ADDENDUM NO.: 03
PROJECT NAME: Design-Build Services for Joint Public Safety Training Campus Phase 01A – Outlot Restaurant Area
CONTRACT NO.: PS3056
DATE OF ISSUE: August 6, 2021

NOTICE OF CHANGES, MODIFICATIONS, OR CLARIFICATIONS TO CONTRACT DOCUMENTS

JPSTC PHASE 1A
COMED UTILITIES | 21-0804

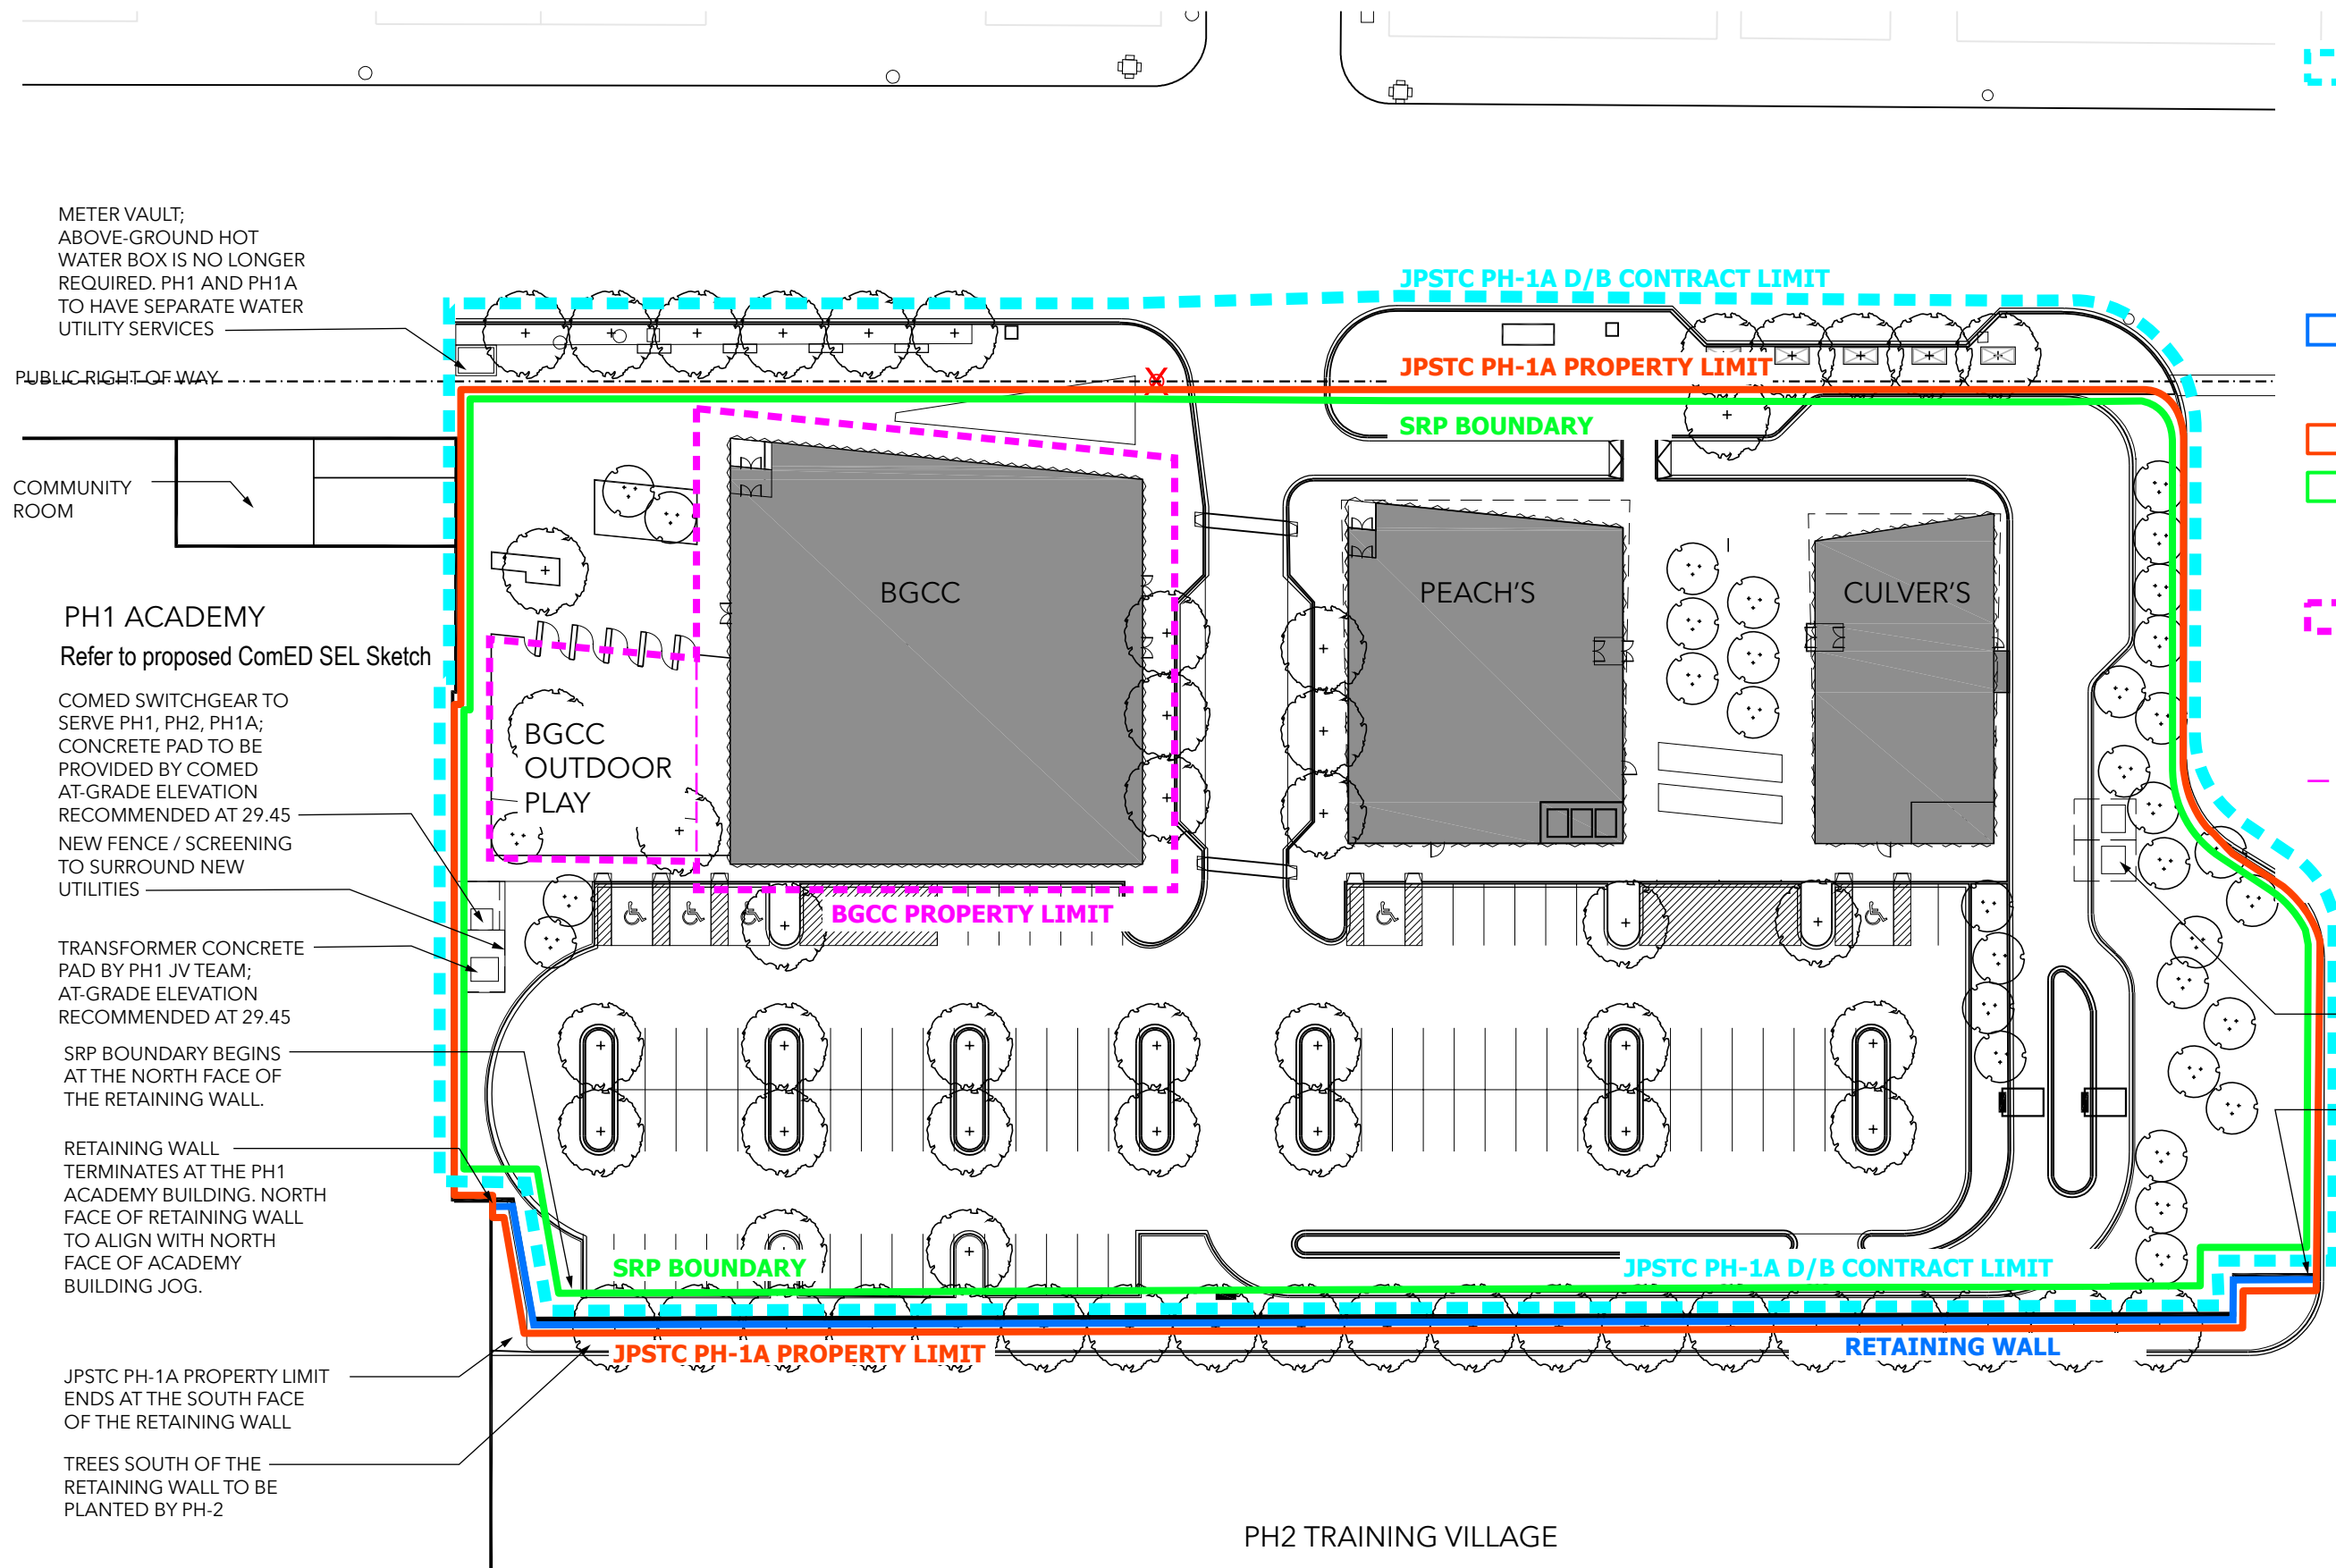
Change 2 DELETE Exhibit J_Feasibility Study drawing labeled DW_LD_LZ_04000-01A_JPSTC_SitePlan_20210616 and **REPLACE WITH** DW_LD_LZ_04000-01A_JPSTC_SitePlanR1_20210804.

METER VAULT;
ABOVE-GROUND HOT
WATER BOX IS NO LONGER
REQUIRED. PH1 AND PH1A
TO HAVE SEPARATE WATER
UTILITY SERVICES
